WELL API NO. 30-015-27558
5. Indicate Type of Lease STATE ☒ FEE ☐
6. State Oil & Gas Lease No.
7. Lease Name or Unit Agreement Name BARBADOS STATE SWD
8. Well Number 1
9. OGRID Number 246289
10. Pool name or Wildcat DELAWARE
11. Elevation (Show whether DR, RKB, RT, GR, etc.) 3334' GL

SUNDRY NOTICES AND REPORTS ON WELLS

Well Name: BARBADOS STATE WD-1		Field: Carlsbad North FLD	
Location: 1980 FSL 660 FEL	SEC 32-T22S-R26E	County: Eddy	State: New Mexico
Elevation: 3334' GL		Spud Date: 10/21/1995	Compl Date: 2/8/1996
API#: 30-015-27558	Prepared by: Jeff Young	Date: 7/9/24	Rev:

Action 362376

CURRENT WELLBORE

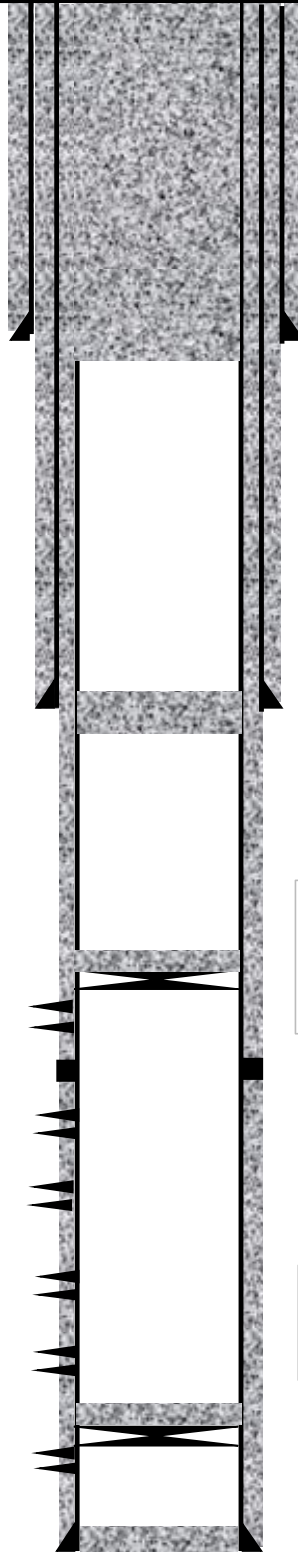
(Only mentioned on SWD application. No
 State reports found) **NOT** Perforations:
(3/4/96)
 3166-4450' Top and Bottom of Delaware
